<< Editor's note: The following is text, tables, and figures that should be substituted for 802.1Qbg D1.2 subclause 42.2.2 as agreed in the 11/2/10 weekly phone conference. Features supported by this change are:

42.2.2 VDP TLV definition

Table 42-1—VDP TLV

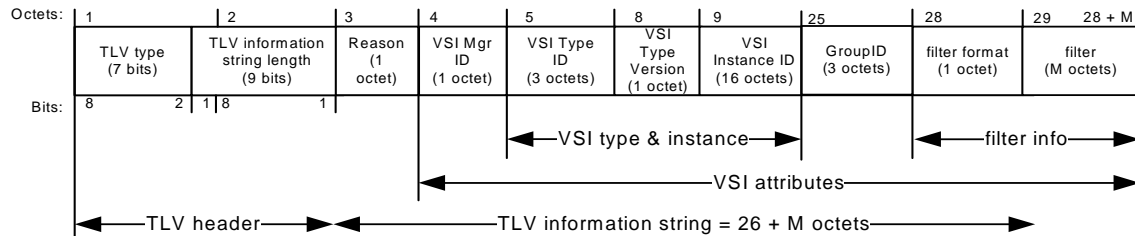
- 1) VID value can be supplied on VDP Rsp when Bridge allocates VID values;
- 2) GroupID is a global identifier for a Service Instance. The Service Instance may be associated with a different local VID value (for example, in each rack) in which the Service Instance is present. The GroupID need not be specified when the Service Instance is known by a single VID value throughout the network. The GroupID can be specified on the VDP Associate Req or Rsp;

- 3) The TLV fields that were previously identified as 'MAC/VLAN format' and 'MAC/VLANs' are now known as 'filter format' and 'filter'.
- 4) Exactly two 'filter formats' are defined (MAC/VID and VID) but other 'filter formats' may be defined in the future that are unrelated to MAC and/or VID;

- 5) There is only one 'filter' value specified per VSI (ie., per TLV); that is, there is not a list of 'filter' values as was previously specified;
- 6) The distinction between 'Basic' and 'Partial' MAC/VID formats is no longer needed.

The VDP TLV is used for discovery and configuration and is exchanged between the Station and the EVBCB. One or more VDP TLVs are transported in an ECPDU. Figure 42-1 illustrates the format of the VDP TLV.
